Project Name: Nuneham Solar Farm

Report Name: Response to Flood Risk & Drainage Objections

Project Number: P21-2947

Proposed Swales
Sheet 1

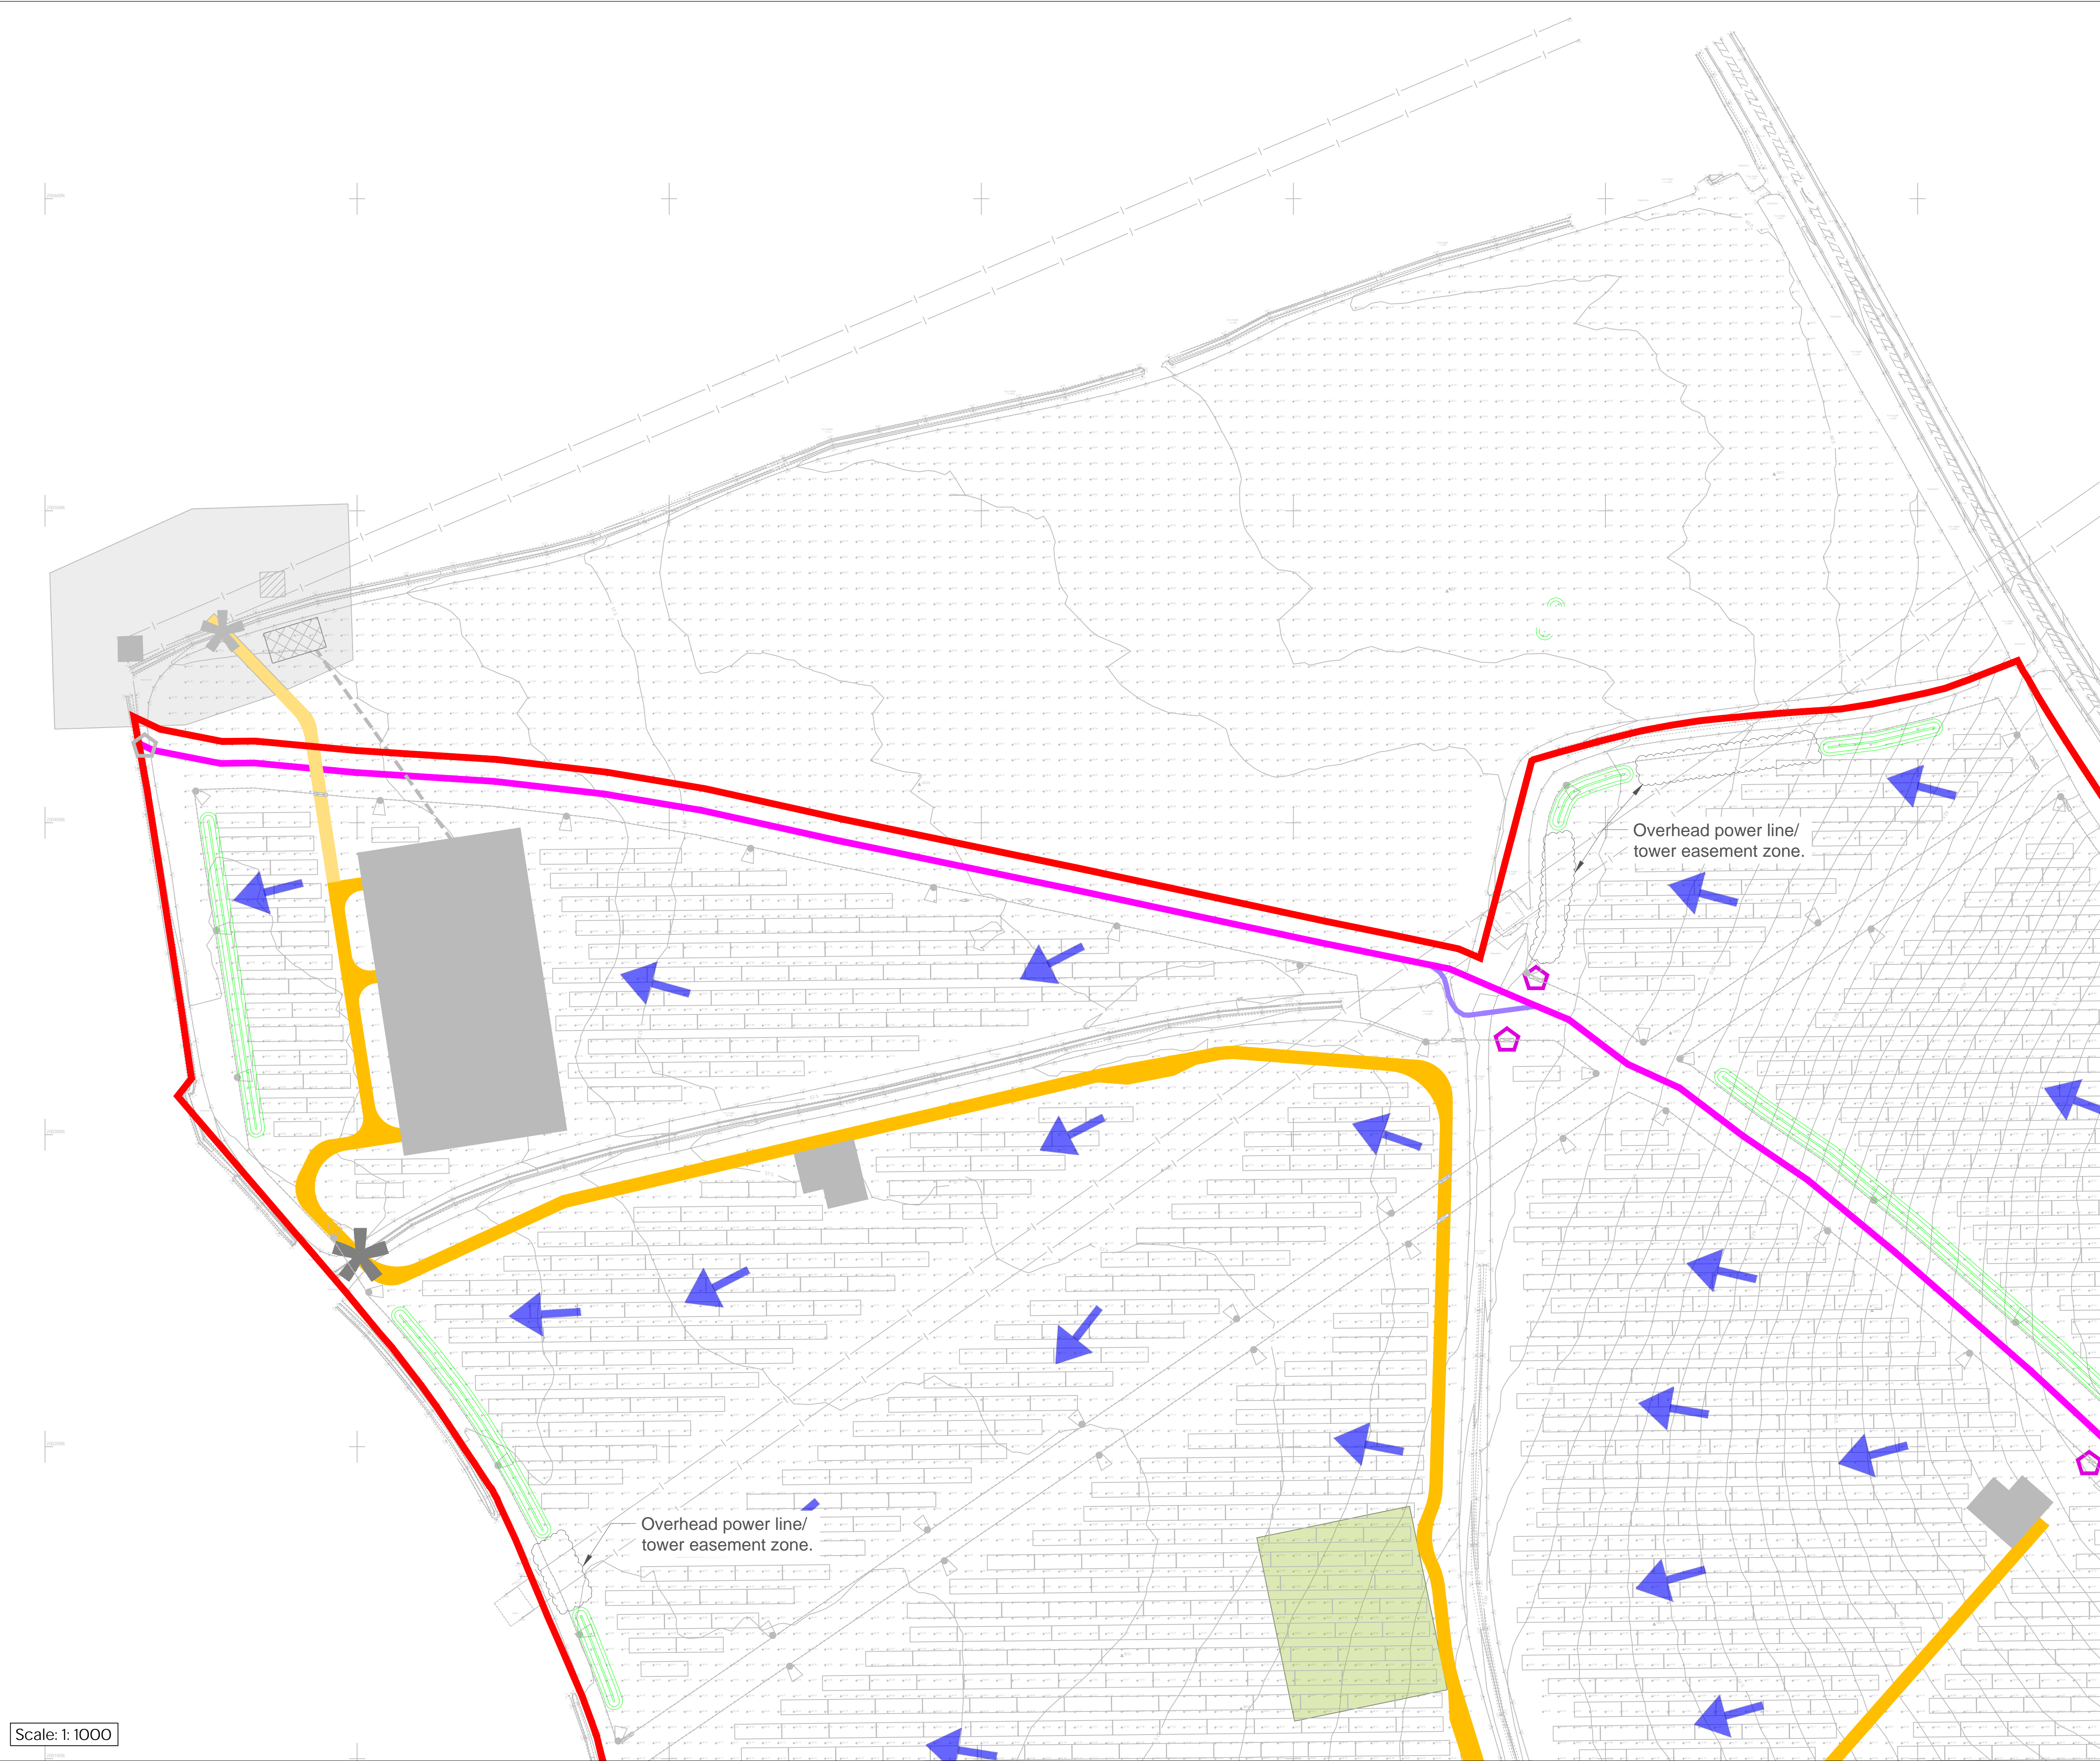
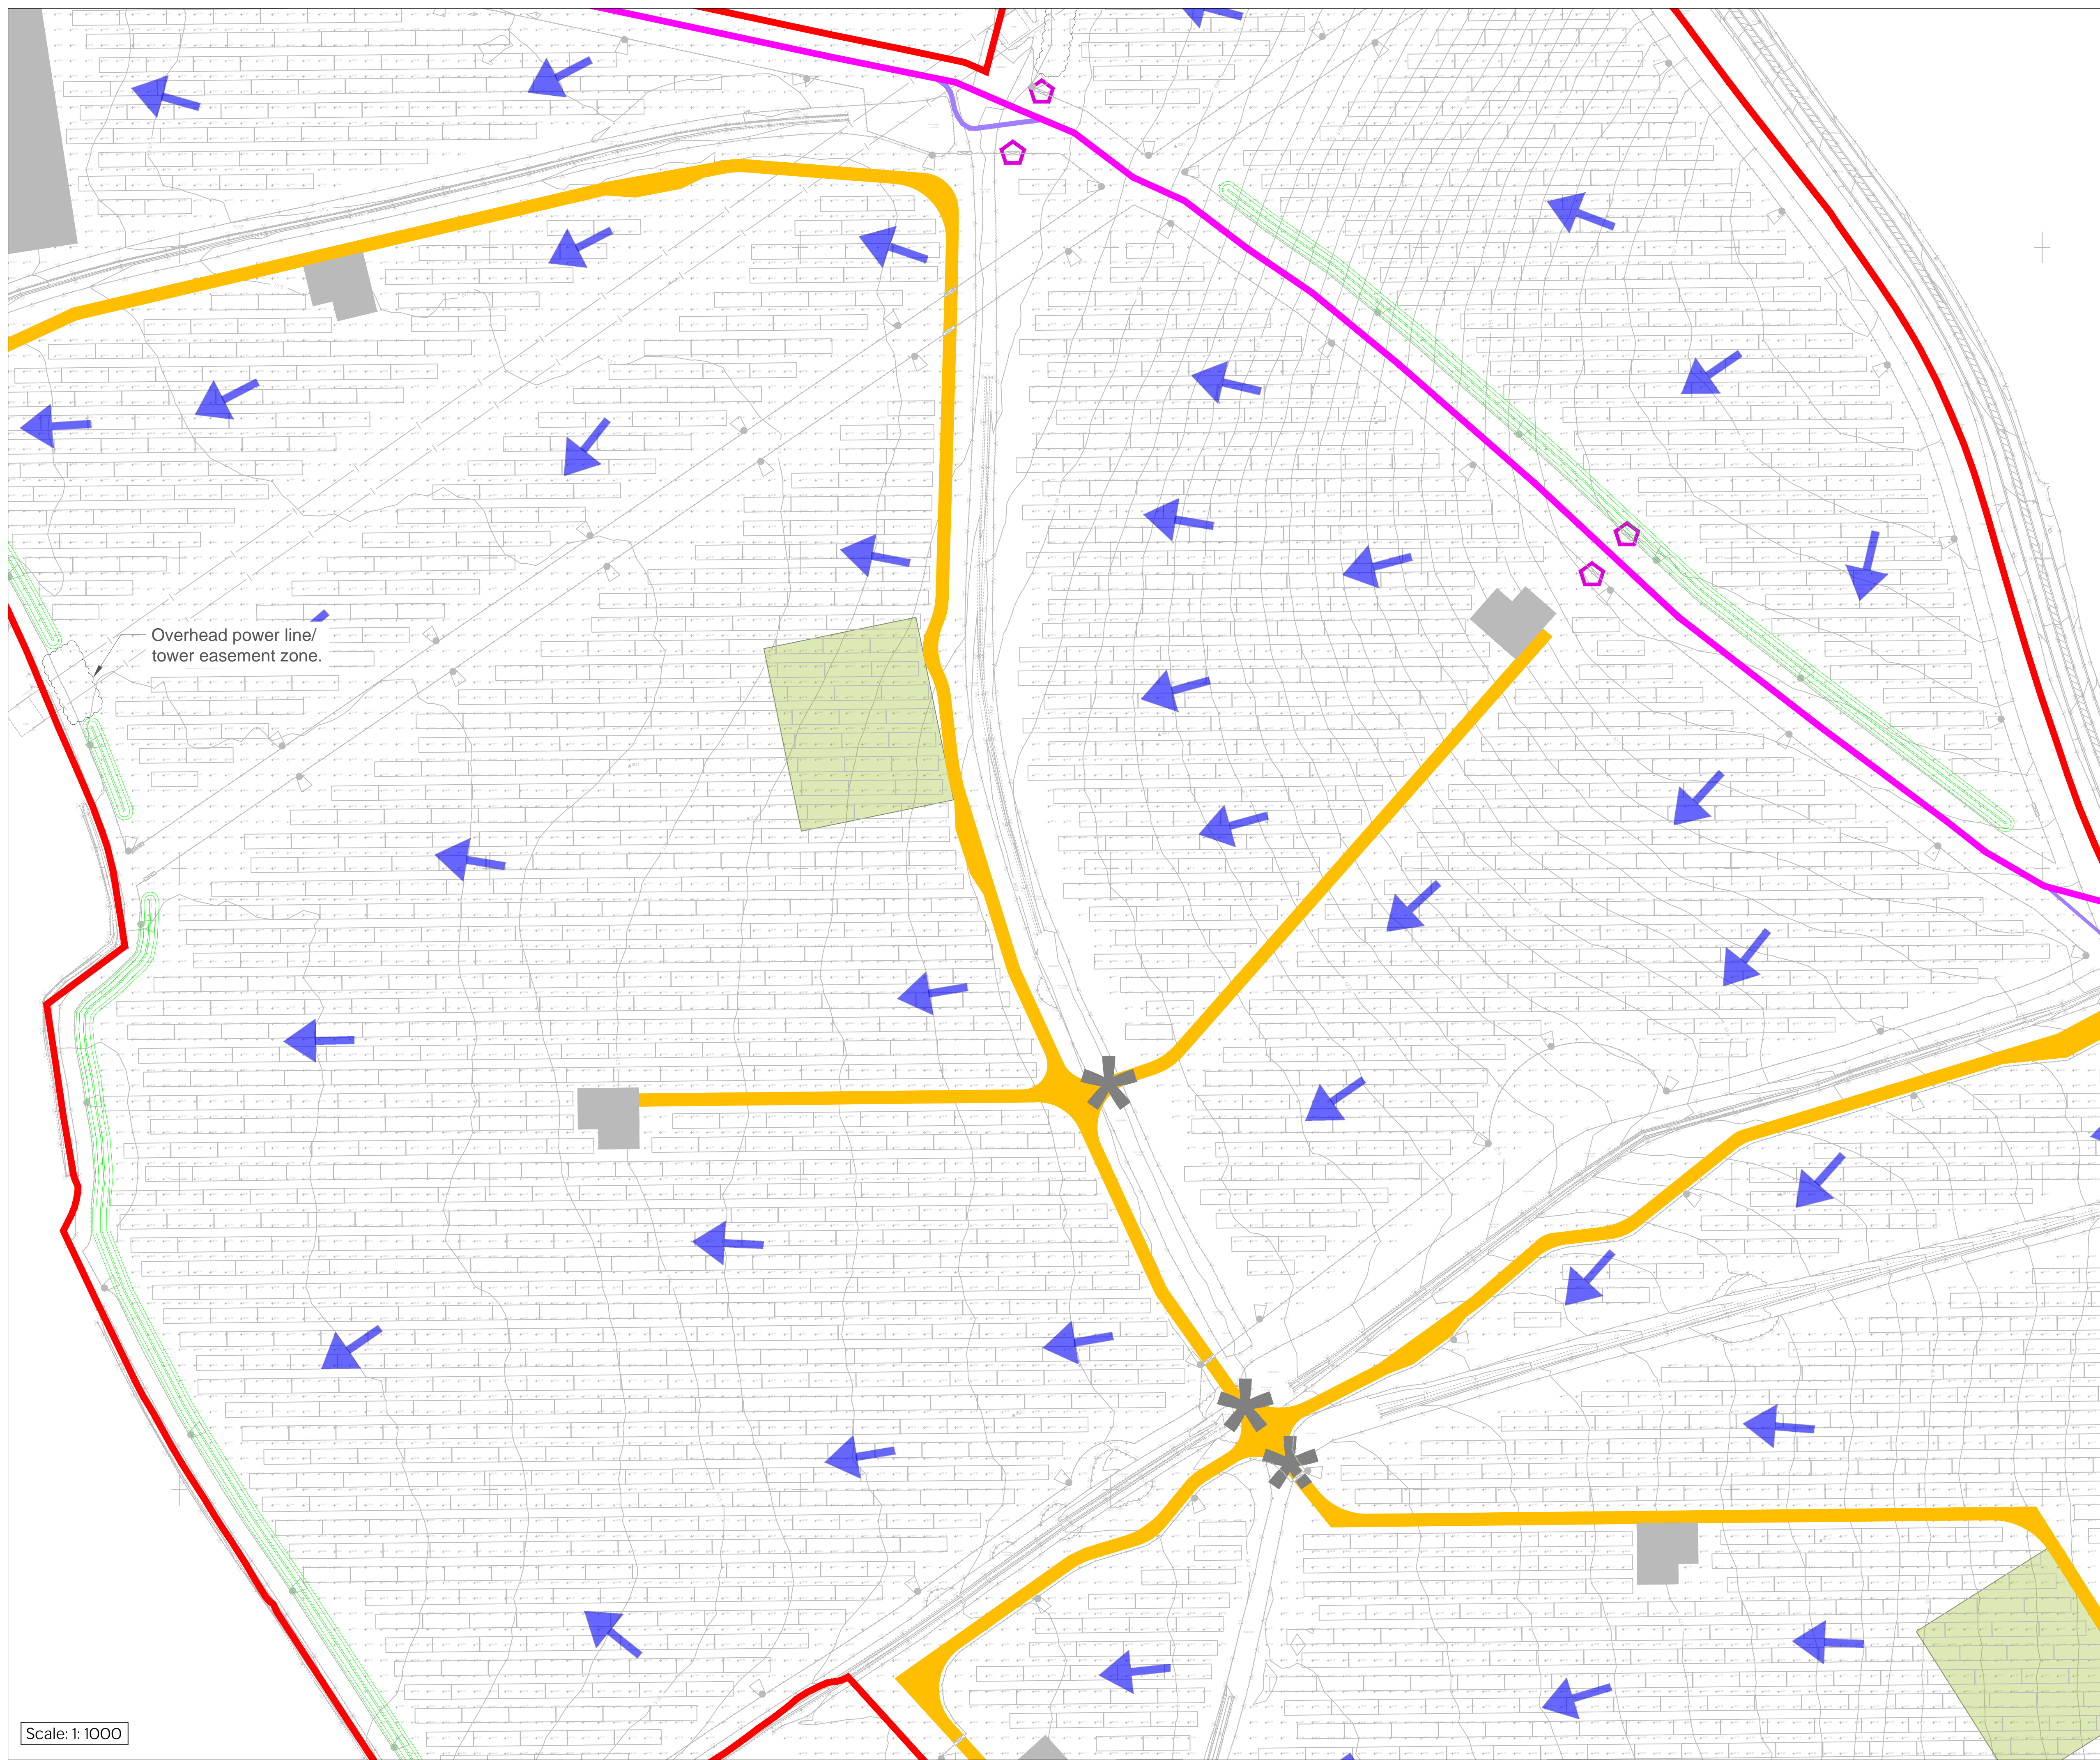
Swales have been discussed within the text to drain access tracks, but no reference to these on the drainage strategy drawing is provided.

All access tracks on site will have a swale alongside them. A typical access track detail for the site is enclosed at the end of this report. It’s noted on this enclosed plan (Figure 6), in reference to the swales, that “actual requirements” will be “determined during detailed design”. In addition to the typical access track detail enclosed at the end of this report, a “Proposed Swales” plan has also been prepared and is enclosed at the end of this report. This plan highlights the access tracks across the site where swales will be provided. The plan also shows several additional swales proposed on site where it has been identified there was not an access track and associated swale at the downslope end of blocks of solar arrays. The proposed swales will help capture and infiltrate and surface water runoff from the site.
